RESS-4-11

'Proposal of Fire resistance test'

Korea Transportation Safety Authority (TS)

Korea Automobile Testing & Research Institute (KATRI)

Test results 1/2

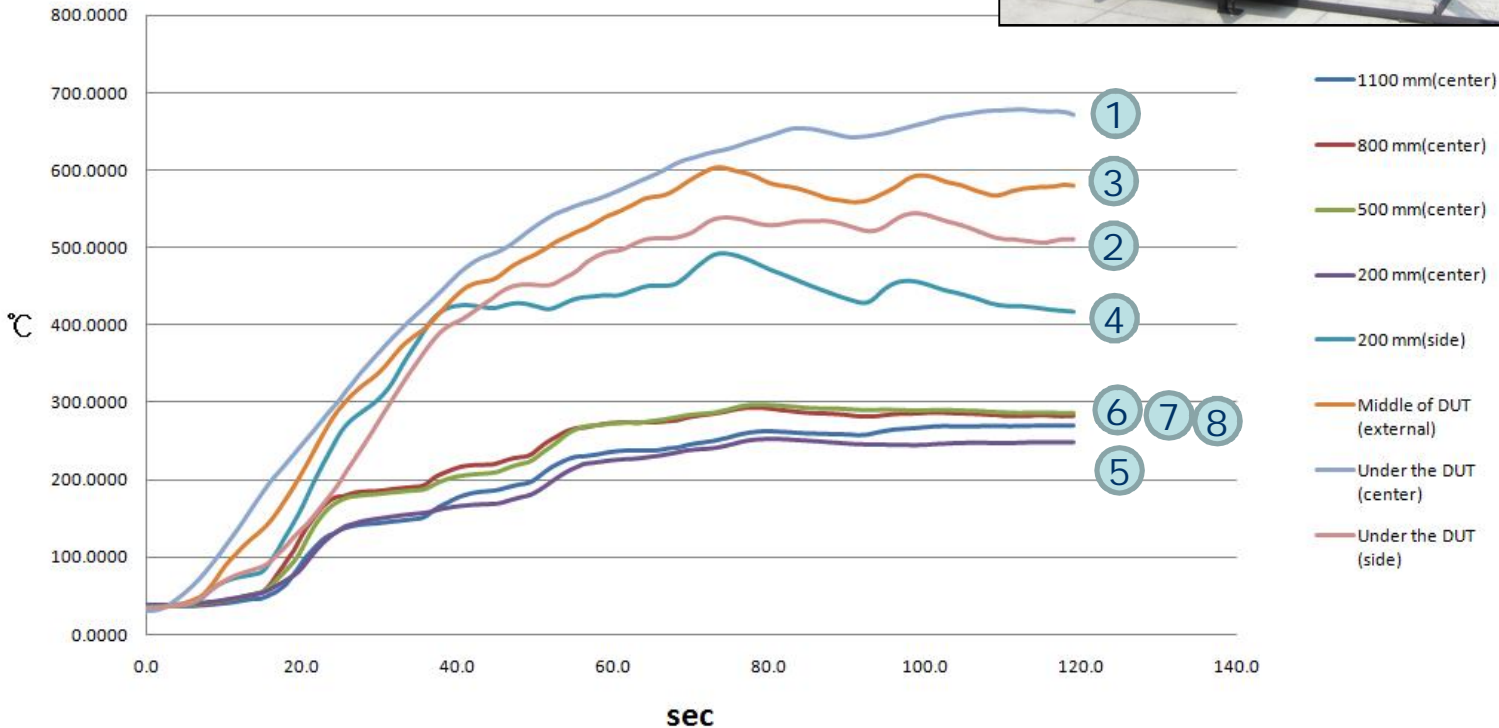
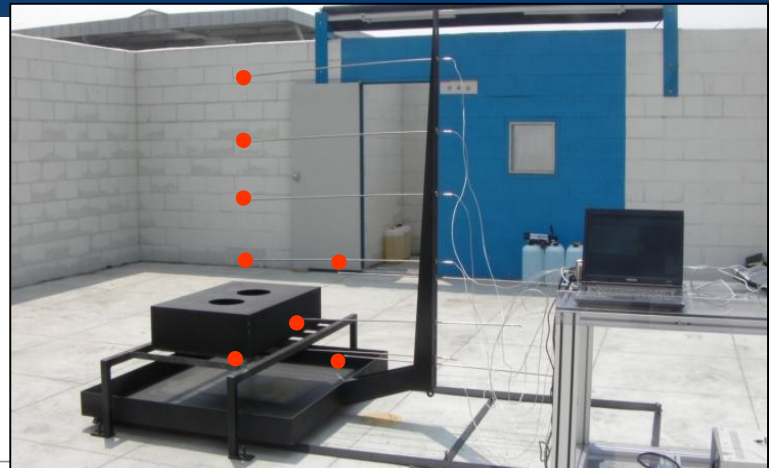
- Despite of the weak wind, temperature curve cannot be easily stabilized
- Even if initial wind velocity is lower than proposal limitation, heat generated by flame causes turbulence
- Temperature at ① is the highest one
